Dr. Bradley Borum, Director of Research, Policy, and Planning
Indiana Utility Regulatory Commission
PNC Center, 101 W. Washington Street, Suite 1500E
Indianapolis, IN 46204

Dated: March 6, 2026

Re: Sierra Club Comments on CenterPoint 2025 IRP

Figure 1. CenterPoint generation mix in the preferred portfolio (Delayed Reference Case)

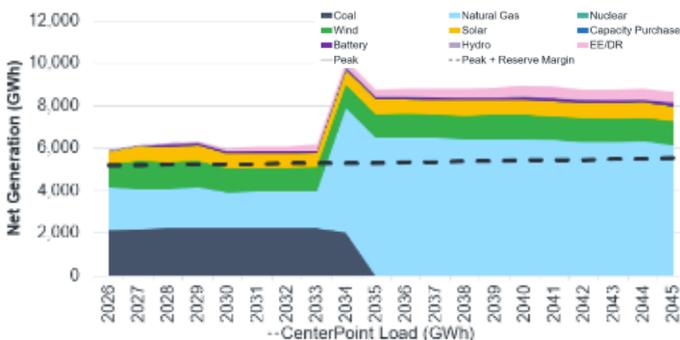
Sierra Club supports CenterPoint in its plan to add BESS at the FBC2 site and encourages CenterPoint to continue looking for opportunities to economically add BESS, solar, and wind resources to its system, as CenterPoint has done for several years. Renewables and battery storage offer a variety of benefits to ratepayers, especially in light of the market uncertainties that CenterPoint highlights in its IRP. One primary benefit of adding renewables to CenterPoint’s system is that these resources will lower ratepayer exposure to fuel price volatility. The preferred portfolio results in a dramatic increase in the percentage of generation that CenterPoint plans to obtain from gas, which increases from around 35 percent in 2026 (2 TWh) to 74 percent in 2035 (6.5 TWh) (Figure 1).

This level of gas reliance, while preferable to coal, is risky, because it leaves customers exposed to fuel price volatility. Since gas is a global commodity, both domestic and global market forces impact price and demand for the resource. When the global market is constrained and fuel prices spike, ratepayers may face unexpected bill increases as a result of increased fuel charges. For instance, when Russia invaded Ukraine in 2022, European gas customers turned to U.S. gas supply, which drove up U.S. domestic gas prices. Those high costs were passed on directly to ratepayers. Replacing gas generation in the preferred portfolio with renewable generation would lower ratepayers' future exposure to a price volatility event.

During its next IRP, CenterPoint should reassess whether battery storage can provide incremental capacity at a lower cost than the ABB7 conversion. It should also continue re-testing the market to see how resource costs are changing and assess the economics of adding solar and wind as energy resources to displace generation from fossil resources.
